ADDENDUM #6

PROJECT : CODESTACK ACADEMY

REF. # : ARCH PROJ. No. 2023-04

DATE : 21 March 2025

S2.2

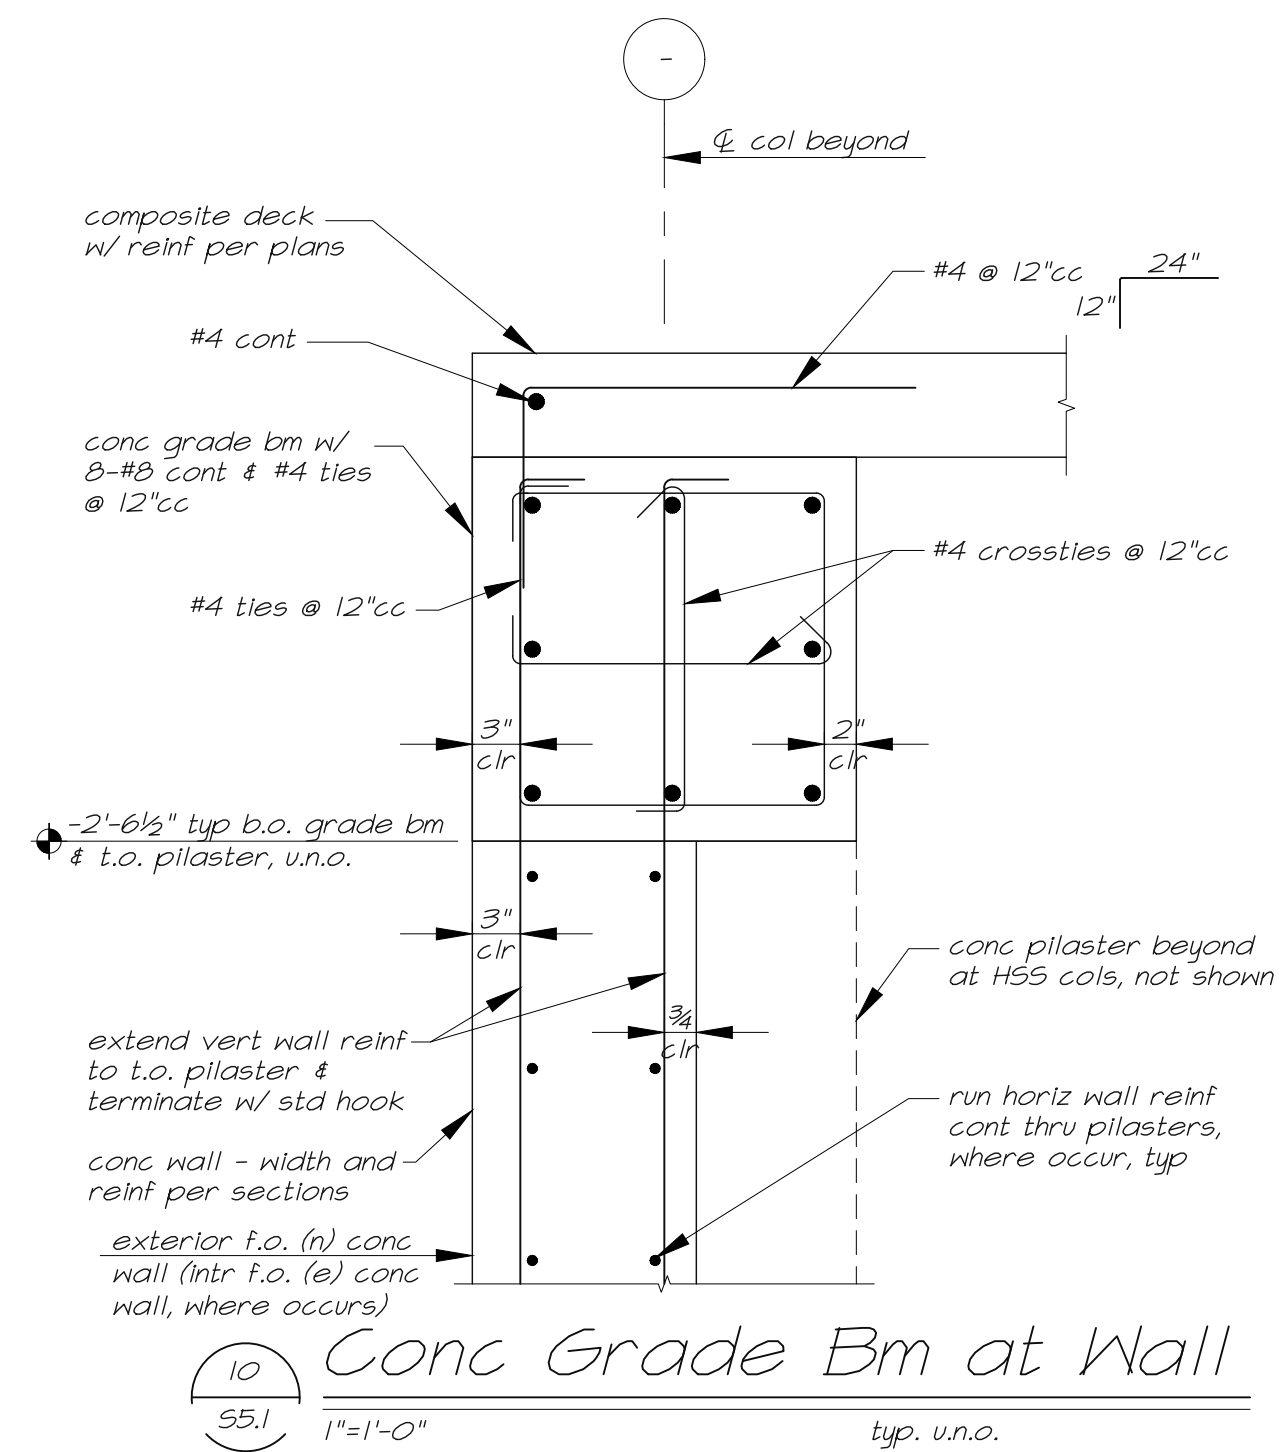
Please confirm if the existing footings along GL9 are continuous or spread footings centered on the existing columns.

Underpinning is noted to extend the full width of the existing footings, please clarify the assumed size of the existing footings for bidding purposes.

The new concrete basement wall along GL's A.2 and Q.2 between GL's 1 & 4 in the structural floor plans does not align with the same wall on the architectural floor plans. The location of the wall as shown on the structural floor plan could create coverage issues for the base plate anchorage at A.2/2.2 and A.2/3.

RESPONSE: It is assumed that there are spread footings at each of the existing concrete columns, but there is no documentation to confirm this.

RESPONSE: Unknown, bid as shown.

RESPONSE: Unless otherwise detailed on the architectural drawings, these columns can bear at the top of the concrete, similar to detail 9/S5.6. Verify with architectural drawings.
